CITY OF WESTMINSTER			
PLANNING	Date	Classification	
APPLICATIONS SUB COMMITTEE	25 July 2017	For General Release	
Report of		Ward(s) involved	
Director of Planning		Maida Vale	
Subject of Report	Dev Site At 221-235 Lanark Rd, Land To North Of 235 Lanark Rd And Land At Scottish Towers, Maida Vale, London, W9,		
Proposal	Details of revised front and rear elevation design treatment pursuant to Condition 4 of planning permission dated 29 April 2016 (15/11007/FULL).		
Agent	BM3 Architecture		
On behalf of	Allenbuild		
Registered Number	17/04304/ADFULL	Date amended/	
Date Application Received	16 May 2017	completed	16 May 2017
Historic Building Grade	Unlisted		
Conservation Area

Details of revised front and rear elevation design treatment pursuant to Condition 4 of planning permission dated 29 April 2016 (15/11007/FULL). Condition 4 states:

10. KEY DRAWINGS

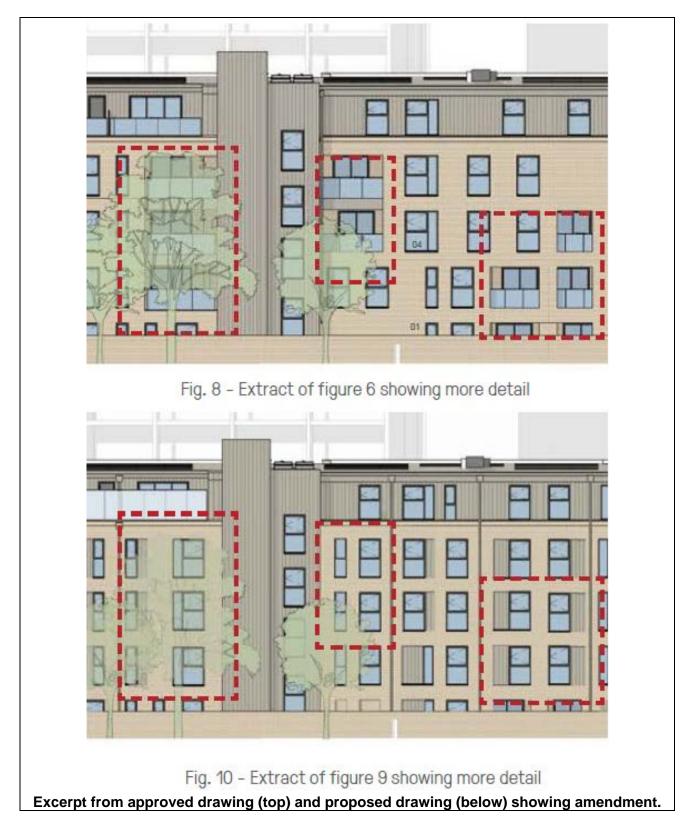
The complete removal of balconies from floors one to three eliminates the occurrence of external activity at these levels to the rear in close proximity to the boundary with Randolph Avenue and is an improvement upon the original plans. In place of the recessed balconies, the façade is now flat and windows installed instead. These changes are highlighted in the Design and Access Statement. In some instances additional windows have been added which seek to address part (a) of the condition with respect to creating greater verticality and order, and the recessed south east corner of the building at first and second floor level which contained two balconies, has been brought forward in line with

On the fourth floor, the building is set back and the balconies positioned on the flat roof of the floor below. Since they are not recessed as they are on the floors below their removal could not occur without increasing the envelope of the building at this level. These balconies have therefore been retained with 1.5m high obscure glazed privacy screens installed. These are shown to the front and rear at fourth floor level, and also at third floor level where the communal terrace meets the rear elevation. At this high level, it is considered these measures are sufficient to mitigate overlooking in either direction.

The proposed alterations to the rear consist of the rearrangement of the fenestration, incorporating windows in lieu of the removed recessed balconies, downpipes and panelling next to windows to create greater order and verticality in the elevation. The appearance is of a more ordered rear façade. The alterations are therefore considered to meet the requirements of the condition.

- Removal of all balconies on the rear elevation across first, second and third floor. Balconies are replaced with windows.
- Inclusion of 1.5m high privacy screen to fourth floor balconies at the rear facing Randolph Avenue and to the front facing St George's School.
- Alterations to the rear elevation design treatment, namely inclusion of windows in lieu of balconies and re arranging fenestration to incorporate greater verticality and order.
